### 3.4 Instrumentation and Control

The information in this section of the reference ABWR DCD, including all subsections, tables, and figures, is incorporated by reference with the following departure.

STD DEP T1 3.4-1 ([Figure 3.4a](#), [Figure 3.4b](#), [Figure 3.4c](#))

**Figure 3.4c Anticipated Transient Without Scram (ATWS) Control Interface Diagram**

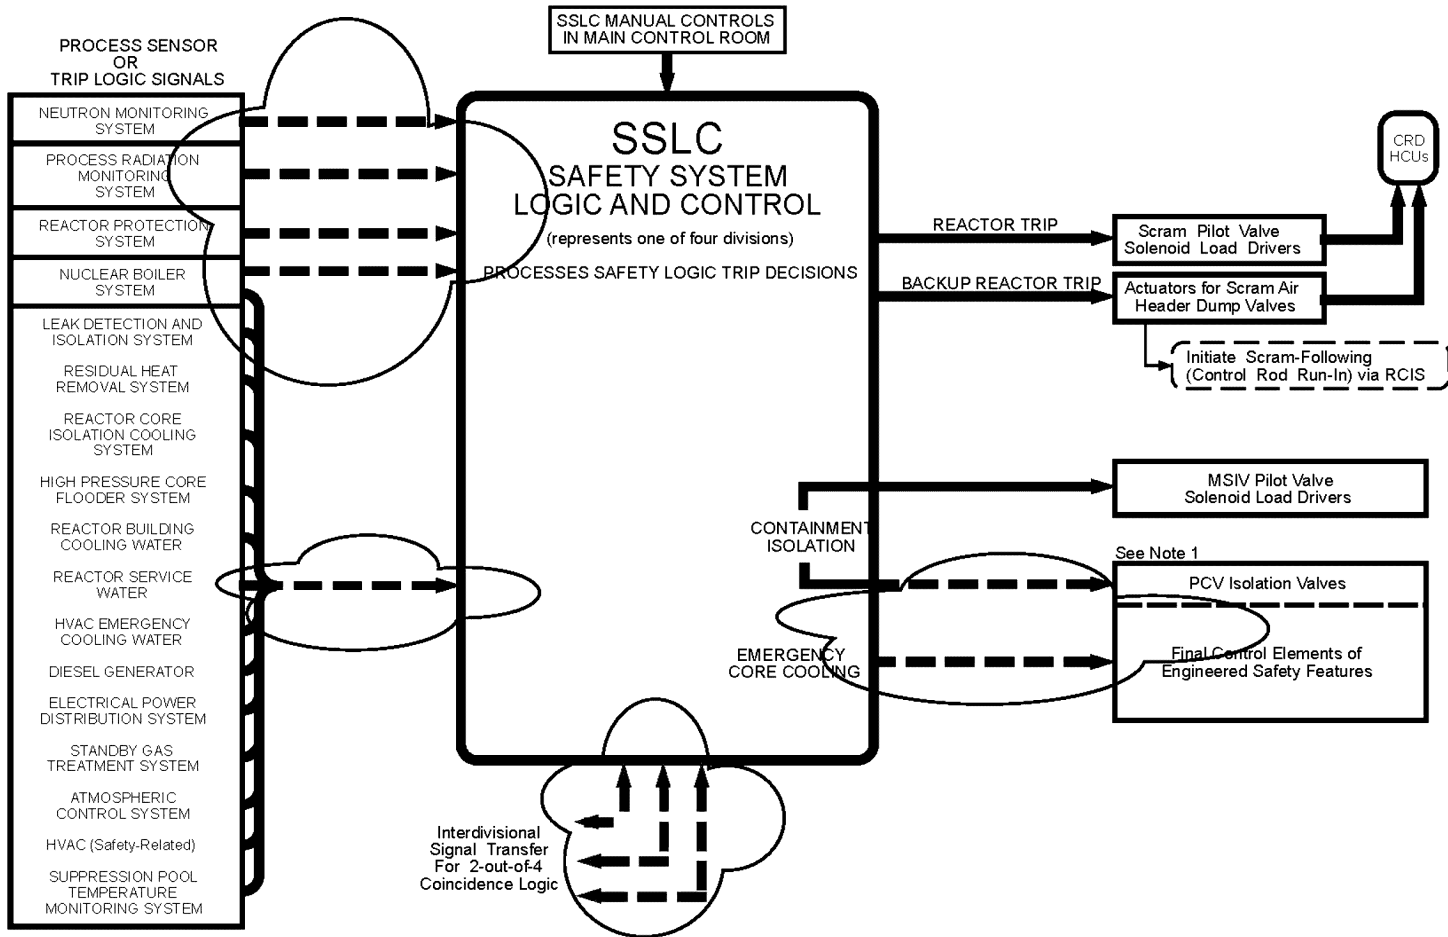
~~These ATWS features are implemented in four divisions of SSLC control circuitry that are functionally independent and diverse from the circuitry used for the Reactor Protection System (Figure 3.4c).~~

Figure 3.4a Safety System Logic and Control (SSLC) ~~Control~~ Interface Diagram

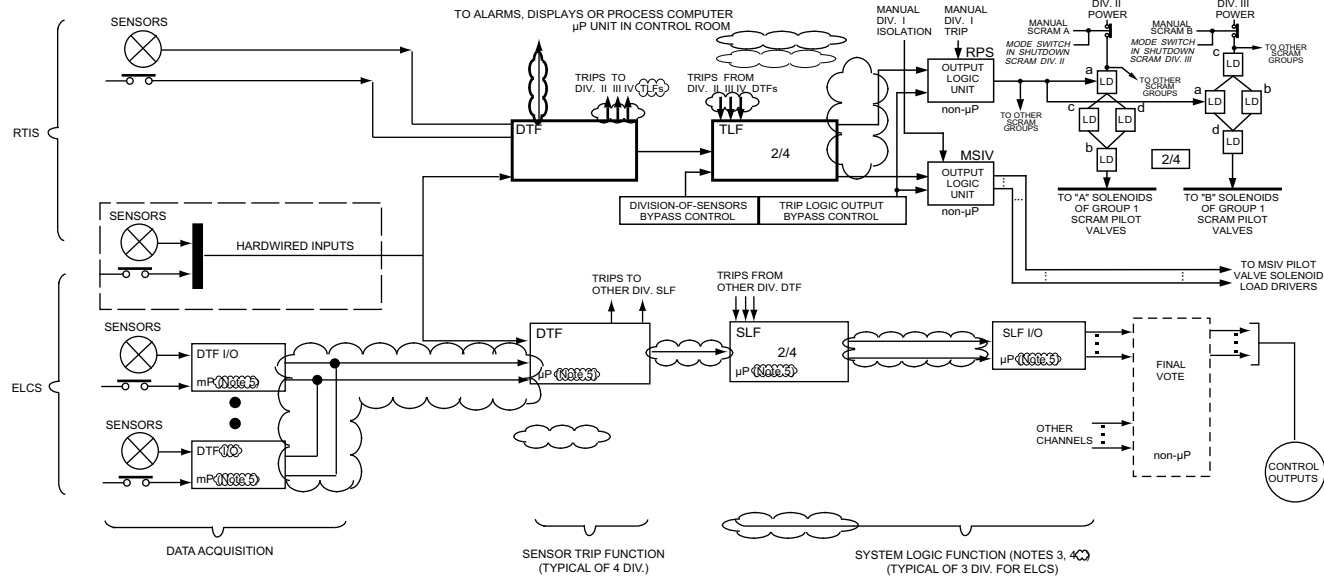
supports the accident mitigation functions. Also included in SSLC are the safety-related portions of the Neutron Monitoring System (NMS), the Containment Atmospheric Monitoring System (CAMS) and the safety-related portions of the radiation monitoring systems. ~~The relationship between SSLC and systems for plant protection is shown in Figure 3.4a.~~

**Figure 3.4b Safety System Logic & Control Block Diagram**

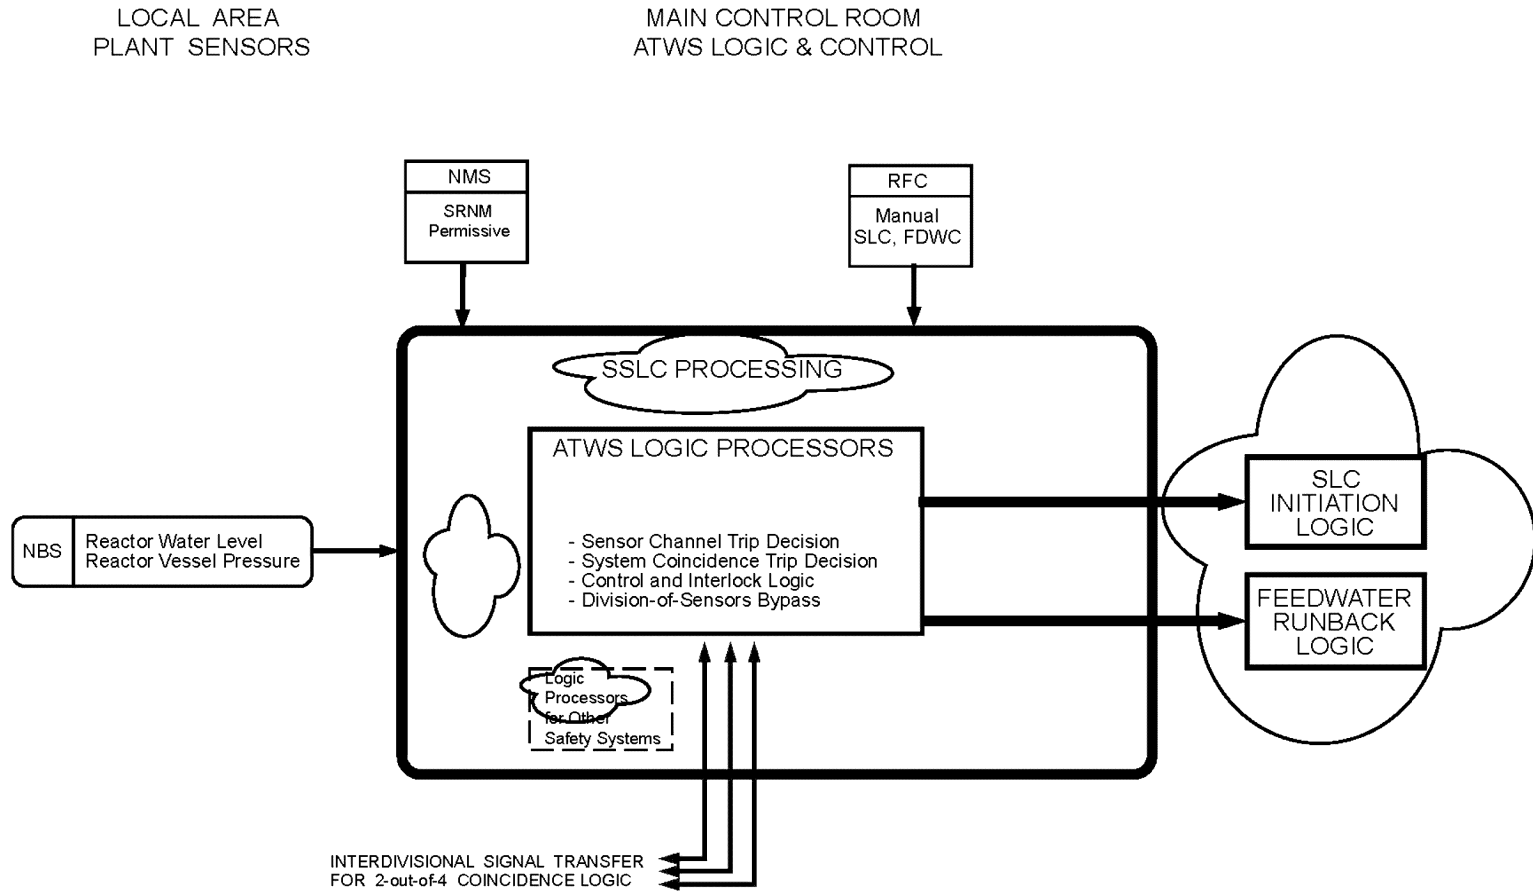
~~The basic hardware functional configuration for one division of SSLC is shown in Figure 3.4b. Each division runs independently (i.e., asynchronously) with respect to the other divisions. The following steps describe the processing sequence and associated function descriptions for incoming sensor signals and outgoing control signals. These steps are performed simultaneously and independently in each of the four divisions:~~

~~As shown in Figure 3.4b, a pair of SLU are located in each of two engineered safety feature (ESF) processing channels, ESF1 and ESF2. ESF1 processes initiation logic for functions which service the reactor vessel at low pressure (e.g. RHR), while ESF2 provides the same support for the vessel at high pressure (e.g. Reactor Core Isolation Cooling (RCIC) System and High Pressure Core Flooder (HPCF) System). Associated LDS and ESF functions are also allocated to these logic channels.~~

- ALL SOLID LINE CONNECTIONS NOT EXPLICITLY IDENTIFIED CAN BE EITHER HARD WIRED OR FIBER OPTIC.
- SAFETY SYSTEM LOGIC FUNCTION (SLF) FOR ECCS FUNCTIONS IS IMPLEMENTED WITH REDUNDANT CHANNELS WITH A MINIMUM 2/2 VOTE OF THE OUTPUT SIGNALS TO PREVENT INADVERTENT COOLANT INJECTION OR DEPRESSURIZATION DUE TO SINGLE SLF ELECTRONICS FAILURE. THE OUTPUT VOTE MAY BE ACCOMPLISHED EITHER BY DIRECT VOTE OF SLF OUTPUT SIGNALS OR BY A SYSTEM VOTE WHERE BOTH VALVE AND PUMP ACTUATION IS REQUIRED TO INITIATE SYSTEM ACTION. BYPASS OF A FAILED SLF CHANNEL MAY BE PROVIDED AS LONG AS THE REMAINING OPERATIONAL CHANNELS PROVIDE A MINIMUM OF TWO SLF CHANNELS FOR ECCS FUNCTIONS.**

- SAFETY SYSTEM LOGIC FUNCTION (SLF) FOR SOME ISOLATION AND SUPPORTING ESF FUNCTIONS MAY BE IMPLEMENTED WITH REDUNDANT CHANNELS WITH A NORMAL MINIMUM 2/2 VOTE OF THE OUTPUT SIGNALS WHERE INADVERTENT ACTUATION OF THE FUNCTION MIGHT REQUIRE UNREASONABLY SHORT REPAIR TIMES TO ELIMINATE OPERATIONAL IMPACT. FOR THESE FUNCTIONS, OPERATIONAL CONTROLLED BYPASS TO ALLOW OPERATION WITH A FINAL 1/1 VOTE IS PERMITTED.**

- EACH FUNCTION MAY BE ACCOMPLISHED BY MULTIPLE PROCESSORS TO MINIMIZE THE HARDWARE AND SOFTWARE COMPLEXITY OR OPERATIONAL IMPACT OF HARDWARE FAILURES, PROVIDED THE MINIMUM REDUNDANCY OF NOTES 3 AND 4 IS MAINTAINED.
